Re: 5818 West Mercer Way, Mercer Island, WA 98040
CAO25-003 Review Letter 1, April 2, 2025

Re: 5818 W Mercer Way
Mercer Island, WA
Permit 2502-028
Private Sewer Repair/Replacement Options

RE: **CAO25-003** Review Letter 1; 5818 W Mercer Way, Mercer Island, WA 98040

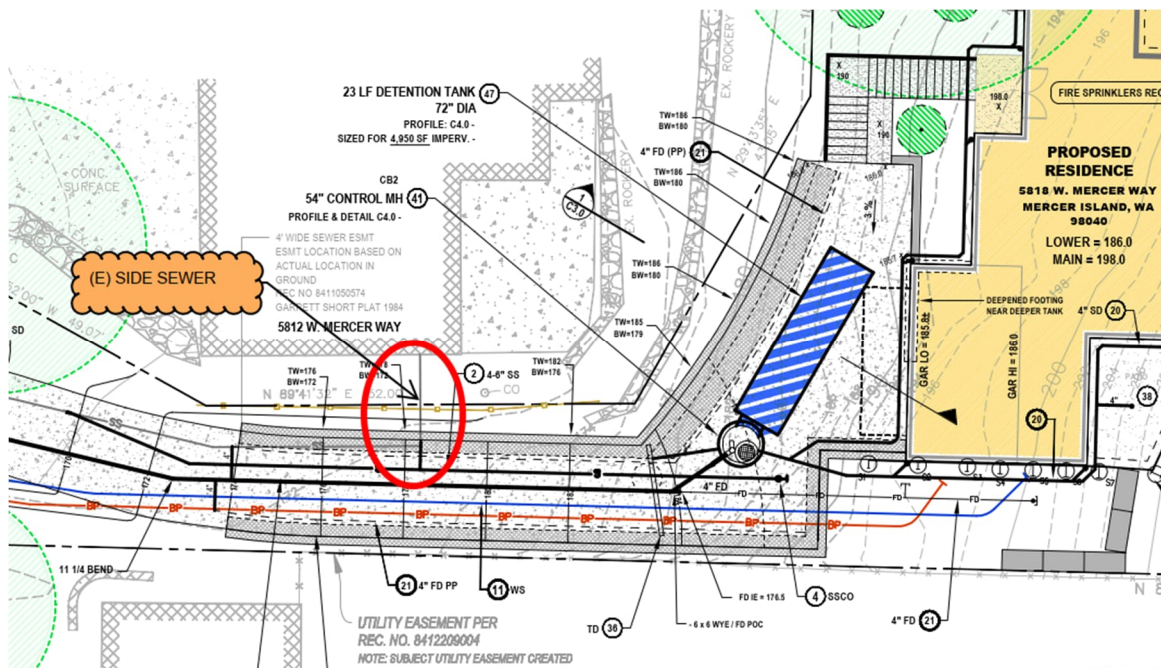
I am the engineer of record for subject single family project. I've been tasked to identify potential repair options for the short section of existing sewer pipe serving 5812 West Mercer address that passes under new retaining wall. See exhibit next page for reference.

The following two non-excavation options briefly summarized are recommended and common procedures for sanitary sewer pipe replacement. I don't expect the increased depth of pipe due to the new driveway grade will impact the future maintenance or replacement costs.

1. Cured-in-Place Pipe (CIPP) Lining:
 - Trenchless replacement
 - Creates a new pipe within existing pipe
 - New pipe is typically a epoxy resin soaked liner
 - Does not require extensive excavation
 - Faster installation relative to traditional dig-and-replace trench excavation
 - Typically lower cost than dig-and-replace trench.
 - Typical design life is 50 years or more
 - A resin-saturated felt tube is inserted into the pipe and cured.
 - No digging required, excellent option anywhere, especially for pipes under walls.

2. Pipe Bursting (if upsizing or replacing deteriorated pipe):
 - Breaks the old pipe while pulling in a new one.
 - New pipe is typically HDPE (high density polyethylene).

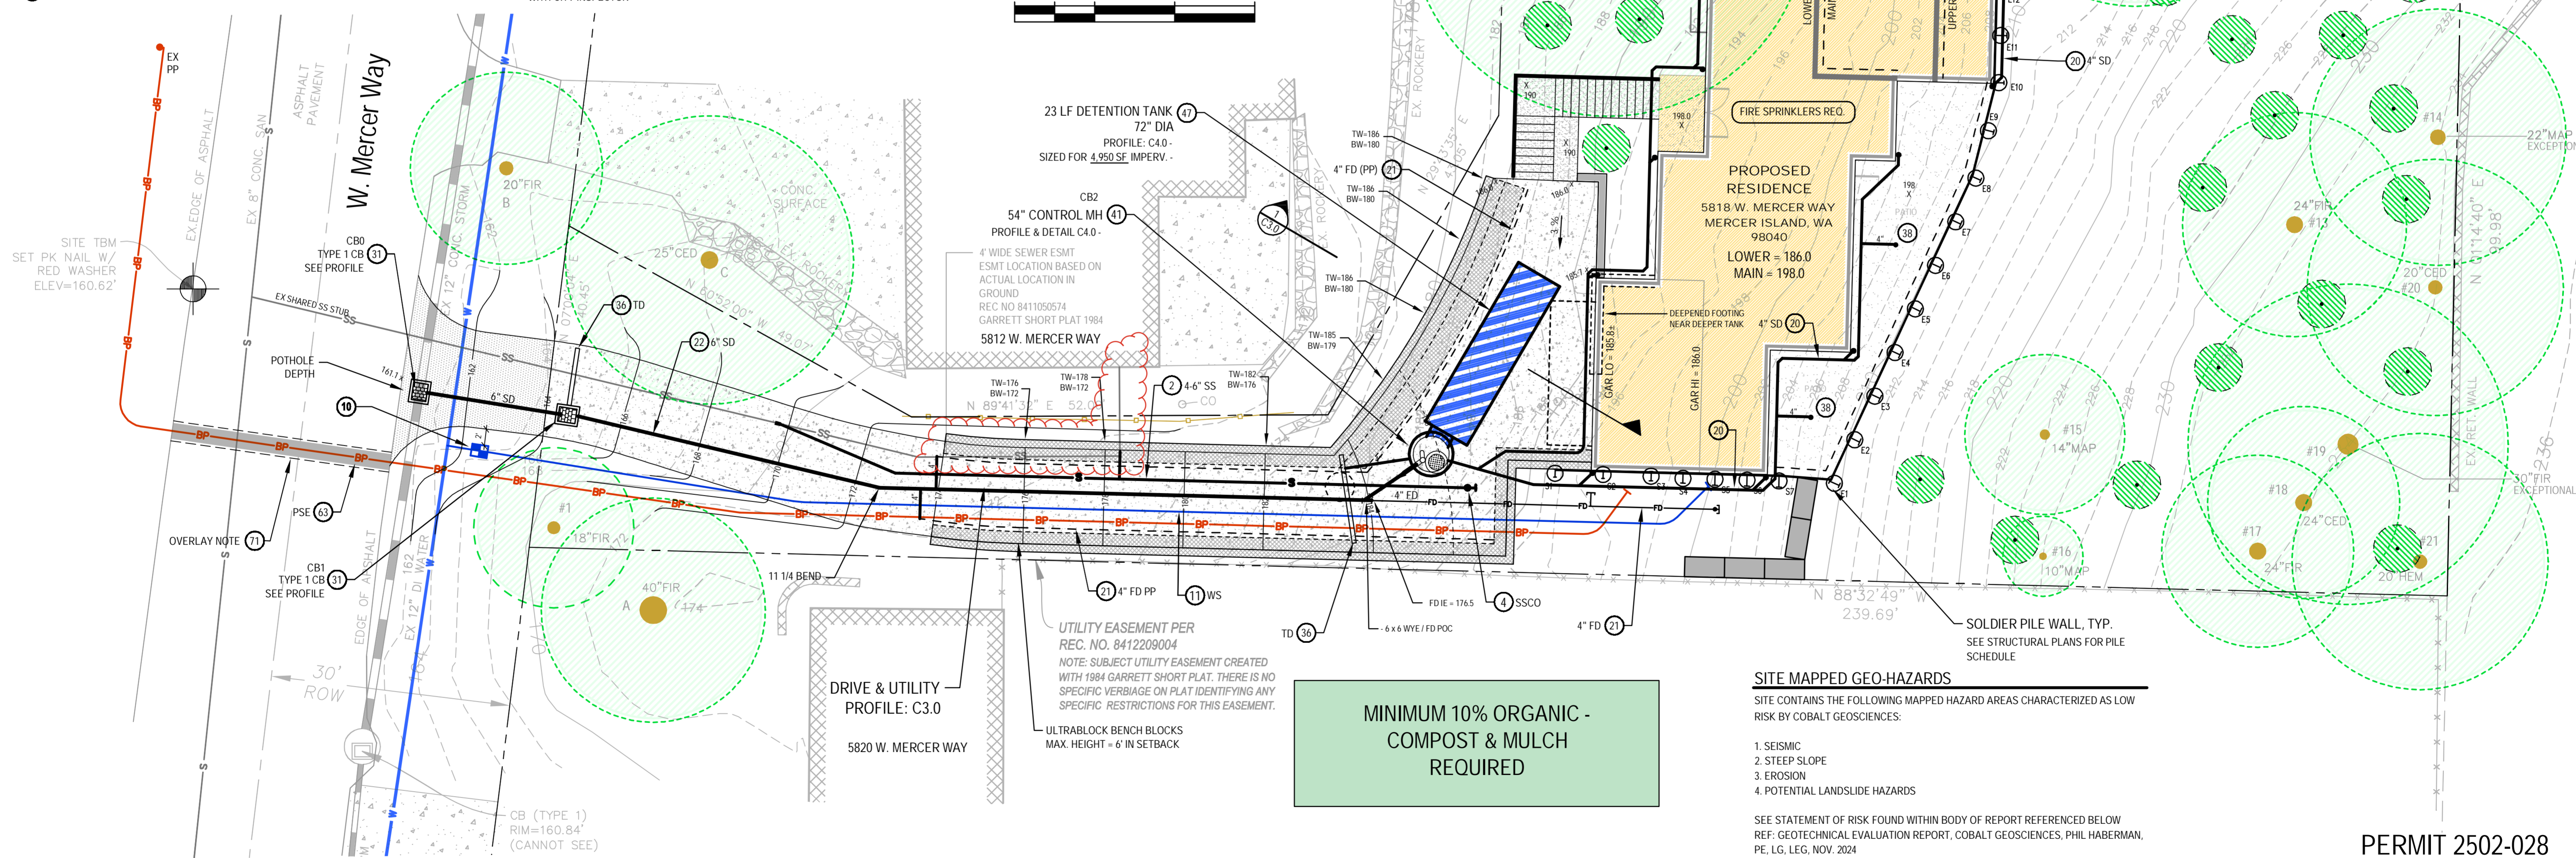
1. EASEMENT: 198412209004 is shown here. Per MICC 19.02.020(H)(2), "Utility and other easements. No structure shall be constructed on or over any easement for water, sewer, storm drainage, utilities, trail or other public purposes unless it is permitted within the language of the easement or is mutually agreed in writing between the grantee and grantor of the easement."
